Access Compliance Report

Public Rights-of-Way

Intersection ID: 18567	Main Street: MICHAEL_BAKER_PL	Cross Street: RUNNYMEDE_LN	Location: NW
ADA ID: A8607CE2B037	Ramp Type: Perp	Initial Pass/Fail: Fail	Overall Compliance: No
		Severity Score: 12.5

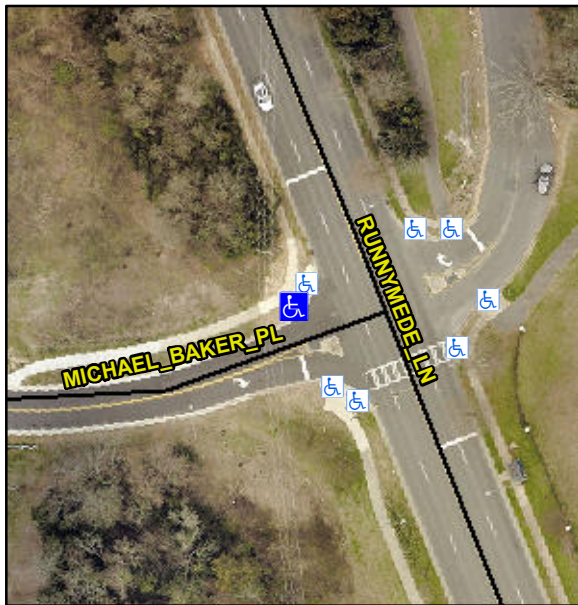
Not Found, R304.2.2

Compliance	Description	Data	Compliance	Description	Data
N/A	Ramp Length (in)	93.0	No	Ramp Slope (%)	9.7
Yes	Ramp Width (in)	59.0	Yes	Ramp XSlope (%)	0.3
N/A	Flare Type LT	N/A	N/A	Flare Type RT	N/A
N/A	Flare Slope LT (%)	N/A	N/A	Flare Slope RT (%)	N/A
N/A	Flare Traversable LT?	N/A	N/A	Flare Traversable RT?	N/A
N/A	Landing Length (in)	N/A	N/A	DWS Provided?	N/A
N/A	Landing Width (in)	N/A	N/A	DWS Contrast?	N/A
N/A	Landing Slope (%)	N/A	N/A	DWS Length (in)	N/A
N/A	Landing X Slope (%)	N/A	N/A	DWS Full Width?	N/A
N/A	Landing Curb? (Y/N)	N/A	N/A	DWS Offset (in)	N/A
N/A	Shared Landing?	N/A			
N/A	Gutter Ponding?	N/A	N/A	Gutter Slope (%)	N/A
N/A	Gutter Lip Ht (in)	N/A	N/A	Gutter X Slope (%)	N/A
N/A	Painted X Walk1?	No	N/A	Painted X Walk2?	N/A
	X Walk 1 Direction	To S		X Walk 2 Direction	N/A
N/A	X Walk 1 Width (in)	N/A	N/A	X Walk 2 Width (in)	N/A
	X Walk 1 Slope (%)	0.1		X Walk 2 Slope (%)	N/A
	X Walk 1 X Slope (%)	5.1		X Walk 2 X Slope (%)	N/A

Remove & Replace Entire Ramp.
